Review of APR+ Level 2 PSA

**Final Report to KINS:
Review of APR+ Level 2 PSA
Revision 2**

February 17, 2012

Figure 2-1 Fault Tree (Logic) for ECSBS

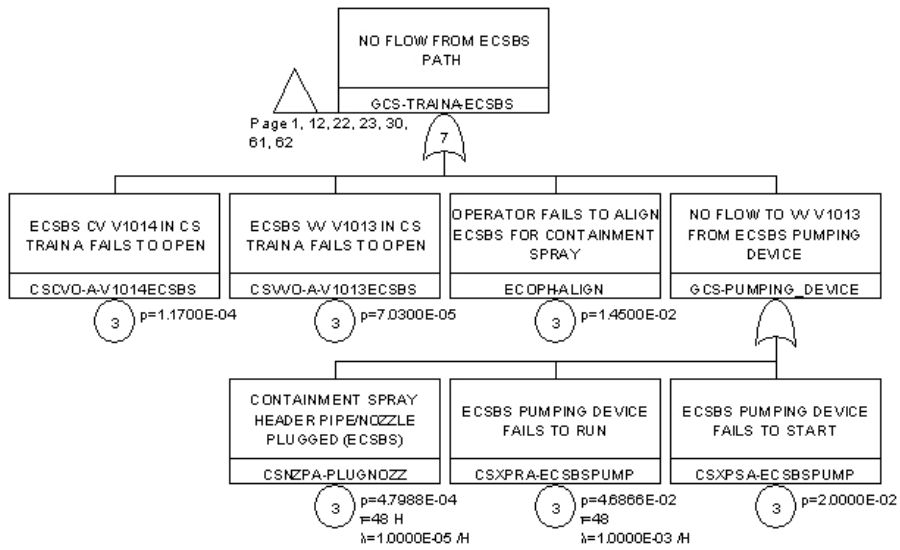
Regarding to the ECSBS unavailability assessment mentioned in the answer to RAI I-4 “Probability of non-recoverable failure of containment sprays”, only short description was given referring to level 1 assessment. Please provide following additional information:

- a. For the APR+, specific EOGs and SAMGs are not available, which are under development by KHNP. In the APR+, several calculations and documents were made to evaluate the ECSBS unavailability but these documents were not written in English, but in Korean. In the analysis, we assumed proper procedures would be prepared for ECSBS operation. Based on the calculations and design documents of ECSBS, the ECSBS unavailability was evaluated.
We provide brief results for ECSBS unavailability calculation which are presented at Figure 2-1, Table 2-1 and Table 2-2. The figure 2-1 shows the Fault Tree (Logic) for ECSBS unavailability, the Table 2-1 presents the database of each basic event for ECSBS, and the Table 2-2 presents the calculations of HFE (Human Failure Event) Probability for ECSBS operation.

Figure 3-1 Convoluted Debris Flow Path

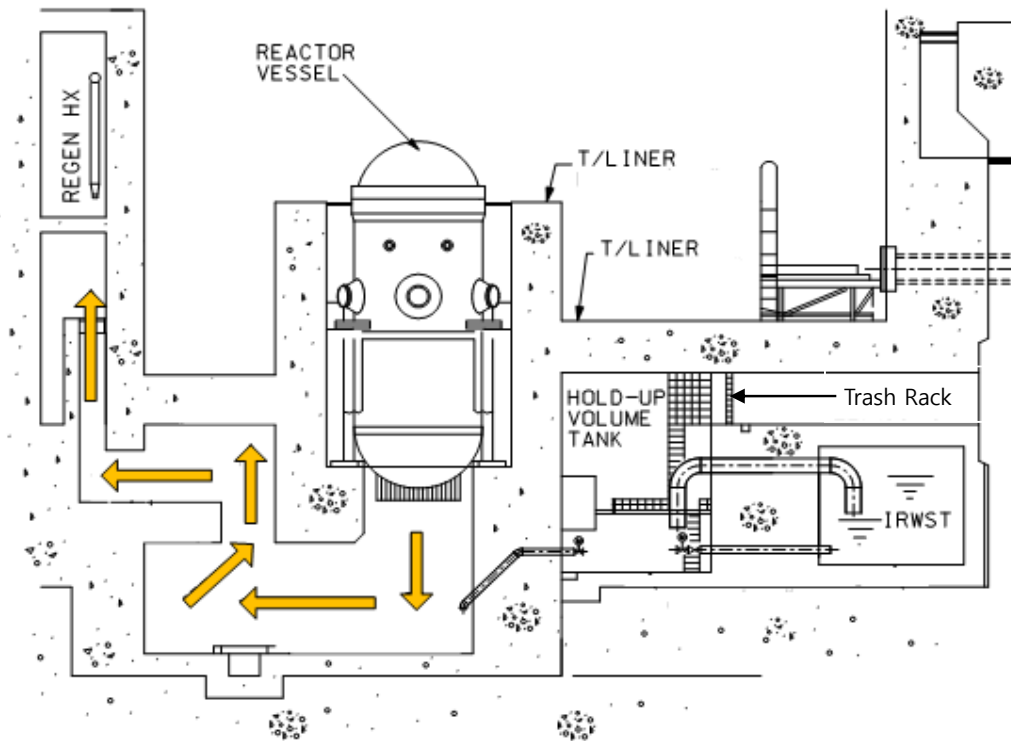
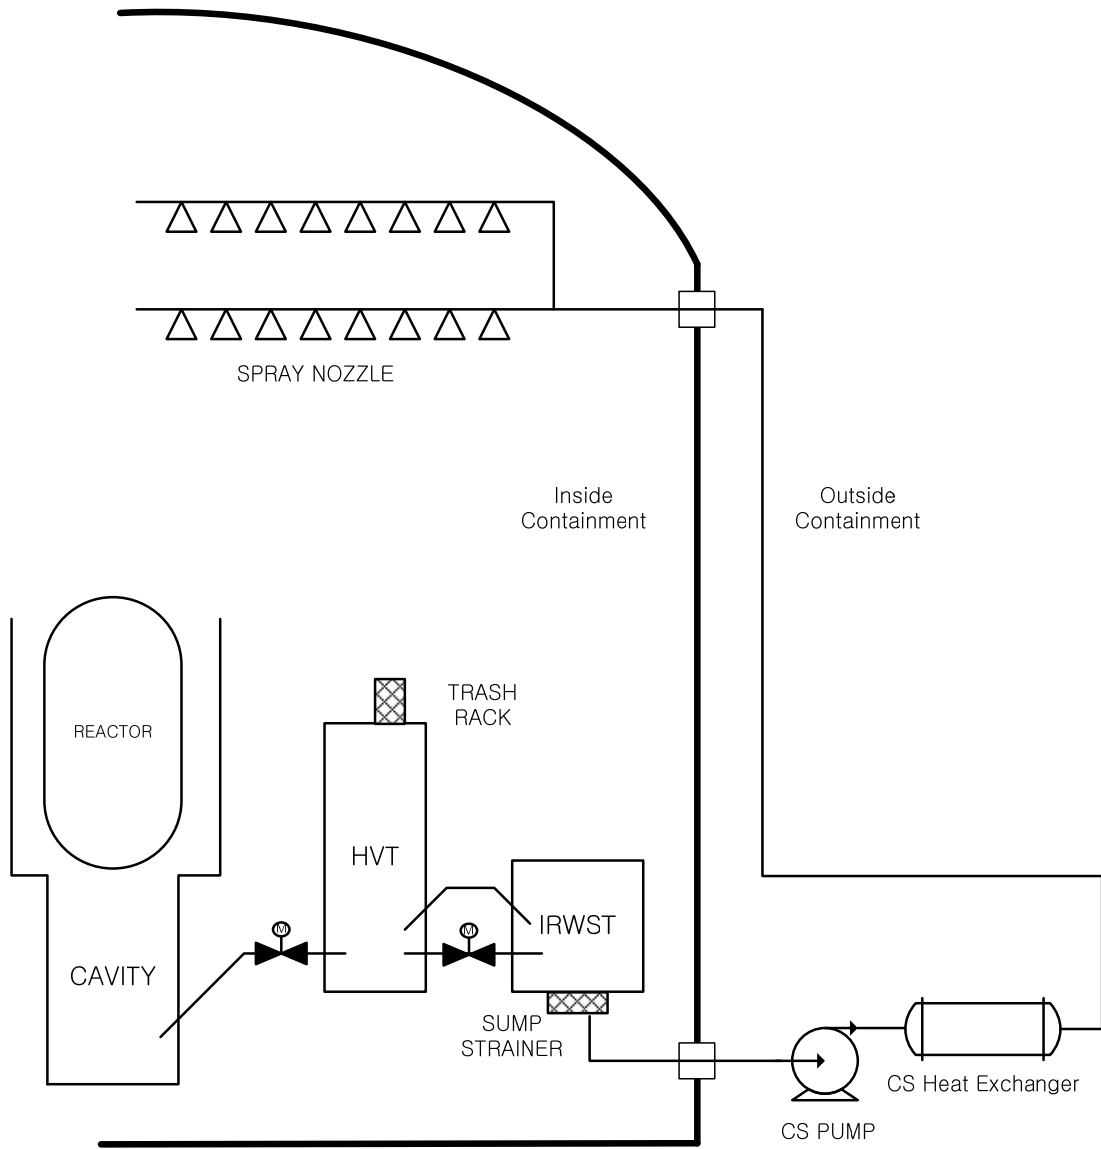
In the answer to RAI I-7, it was explained that CS failure probability was based on engineering judgment and does not depend on cavity conditions. Please provide following additional information on that.

- a. As shown in Figure 3-1, the cavity of the APR+ is designed to minimize debris entrainment and subsequent debris dispersal into the upper compartment of the containment. The primary steam exits via a convoluted pathway above the top of the core debris chamber and into the cavity access area and out through louvered vents under the regenerative heat exchanger room. As a consequence the dominant hot gas and corium carryover pathway will be to the lower portion of the containment where the containment shell is fully protected by the secondary shield wall. It should be noted that this pathway provides limited resistance to gas flow, but is considered very deleterious for the entrained solid flow. The APR+ is also equipped with an offset core debris chamber designed to de-entrain and trap the debris ejected during a reactor vessel breach. The reactor cavity debris chamber and exit shaft have been designed such that following a failure of the reactor vessel high inertia corium debris would de-entrain and collect in the debris chamber while the lower inertia steam/hydrogen/air mixture would negotiate a right angle turn and exit the reactor cavity via a convoluted vent path. As a consequence little corium is expected to be entrained in the gas flow.

The Figure 3-2 shows the schematic layout of the cavity, HVT, IRWST, and Containment Spray. As shown in Figure 3-2, the flow path from IRWST to Containment Spray is a circular loop as follows;

Figure 10-1 Containment pressure in SBO with dry cavity and without spray

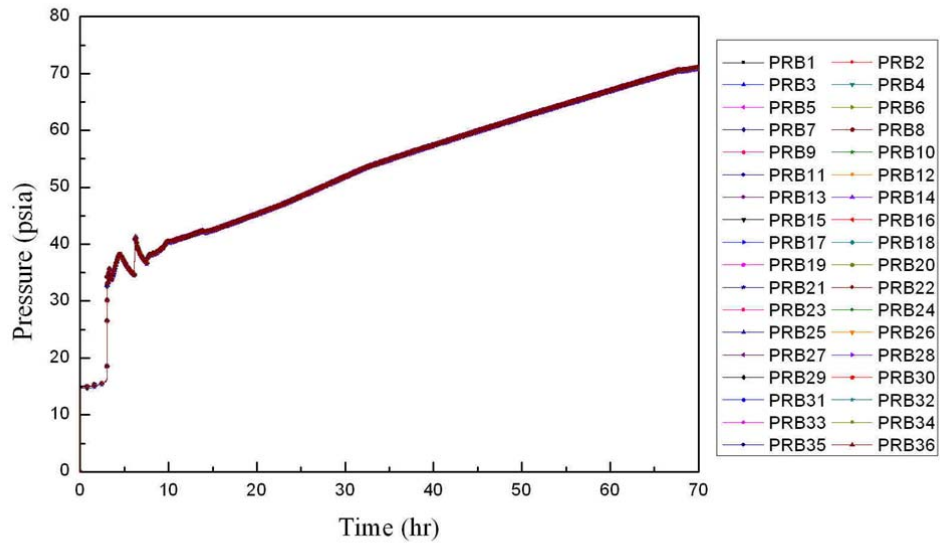
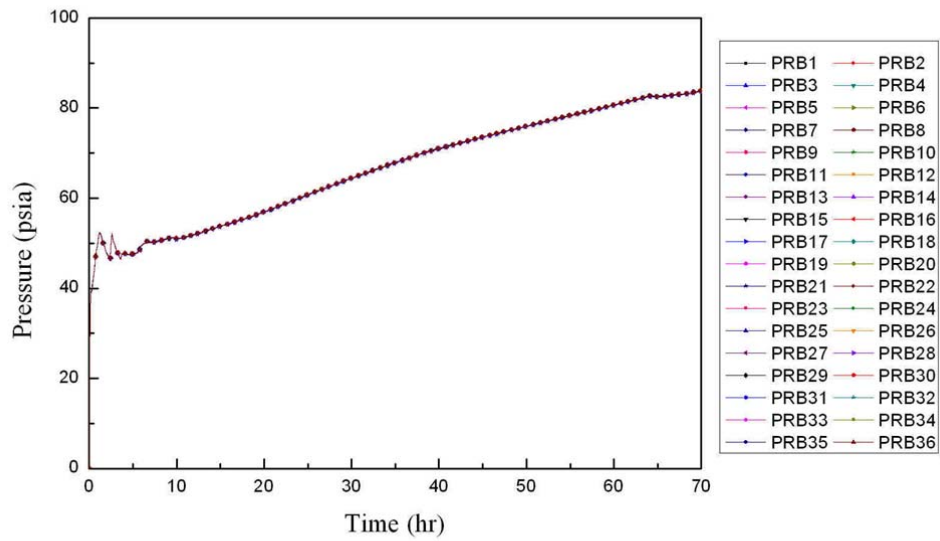
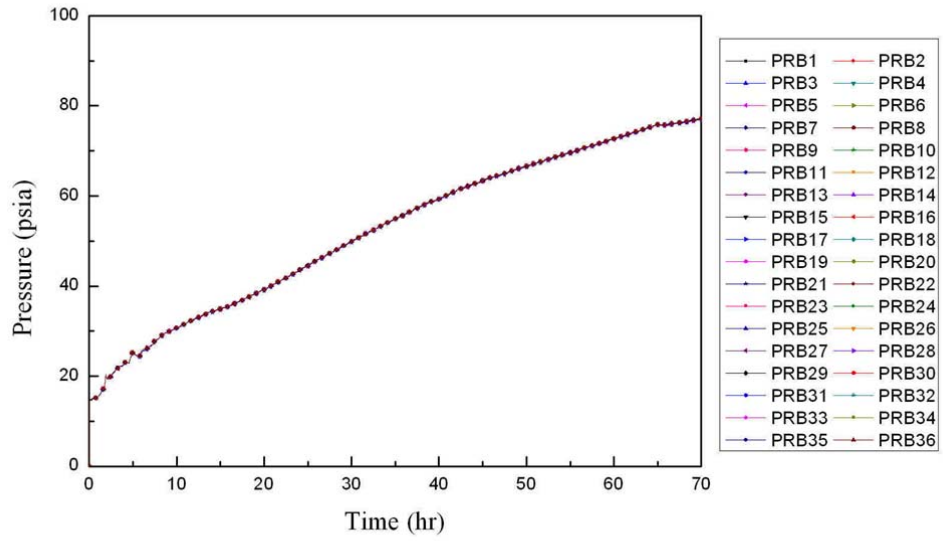
In the bottom of the page 201 of the report, it was explained that combined effect of RCS water vaporization and core concrete attack is insufficient to cause containment failure due to containment over-pressure (Case B). Please provide the following information supporting that.

- a. The APR+ plant is under design stage and there is no plant specific information about concrete at this time. However, considering reference plants, it is expected that the type of concrete for the APR+ would be basaltic aggregate concrete type. According to the severe accident analysis report for the reference plants (SKN 3&4), the concrete type assumed is basaltic aggregate concrete which is typical for most Korean NPPs. (Reference: "Severe Accident Analysis Report for Shin Kori Units 3&4, KEPCO E&C, Dec. 2009)

In this analysis, the containment pressure does not reach about 90 psia (75.3 psig) for all cases above. The analysis results for three cases are presented at Figure 10-1 through Figure 10-3. Therefore, from comparison of these results with the containment fragility curve, the probabilities of containment rupture or leak by over-pressurization seem to be negligible for the dry cavity condition.

Figure 12-1 Fragility curve for “Rupture before Leak “

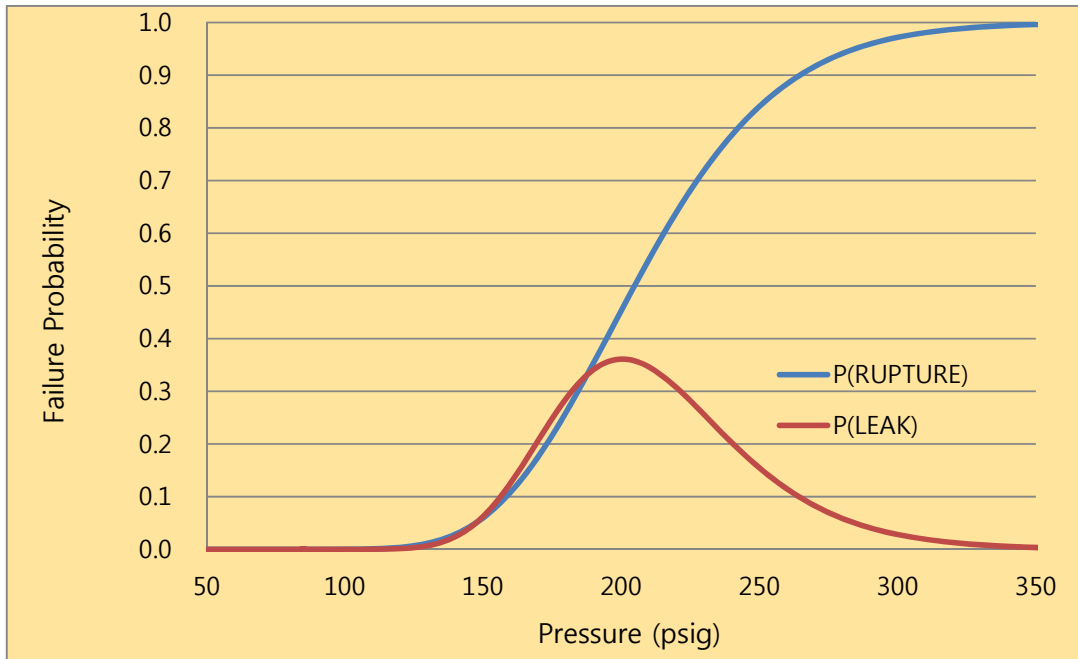
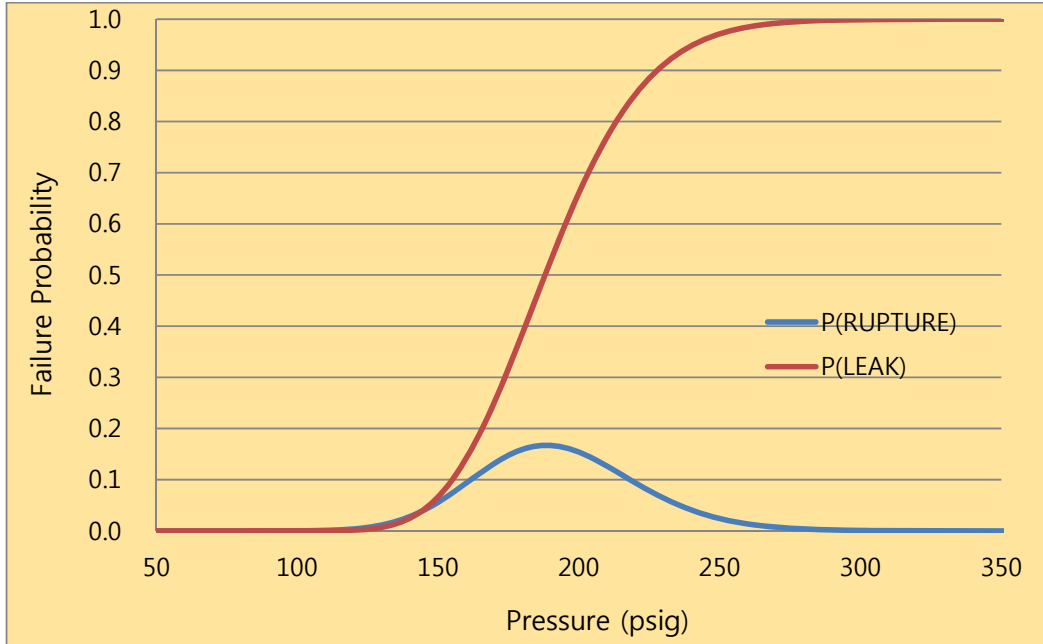
In Section 3.2.1.2.1, it was explained that the median pressure capacity of leak failure mode (188.0 psig) is lower than that of the rupture case (207.8 psig). However, in Table 3.2-1, the rupture probability (P(Rup)) for a given pressure is always greater than the leak probability (P(Leak)). Regarding to this, please provide following information.

- a. Reasoning to assume rupture in advance of leak failure
- b. Median value of leak and rupture failure mode if we assume “Leak before Rupture” failure mechanism according to the following procedure.
 1. Assume leak failure occurs first for a given pressure : P(Leak)
 2. For the remaining fraction, calculate P(rupture)
- c. Explanation on the effect assuming that rupture is preferred mode of failure.

- a. The high probability of rupture does not mean rupture occurs in advance of leak. The reason to assume rupture in advance of leak failure is that it causes conservative results in source term release to the environment. The source term with rupture failure mode is more severe than leak failure.
- b. The median values of leak and rupture failure mode do not change, even if the assumption “Leak before Rupture” is made. However, P(Rup) and P(Leak) for a given pressure should be re-evaluated by using the following expressions.

- c. Figures 12-1 and 12-2 show that the rupture and leak failure probabilities in the pressure range up to about 145 psig are practically same for both cases, respectively. The AICC-calculated pressures of 92.4 psig and 121.4 psig (referring to

Table 3.2-2 of APR+ PSA technical report) are also in that pressure range. Therefore, the assumption of "Leak before Rupture" might make no significant differences from the original APR+ Level 2 PSA results.
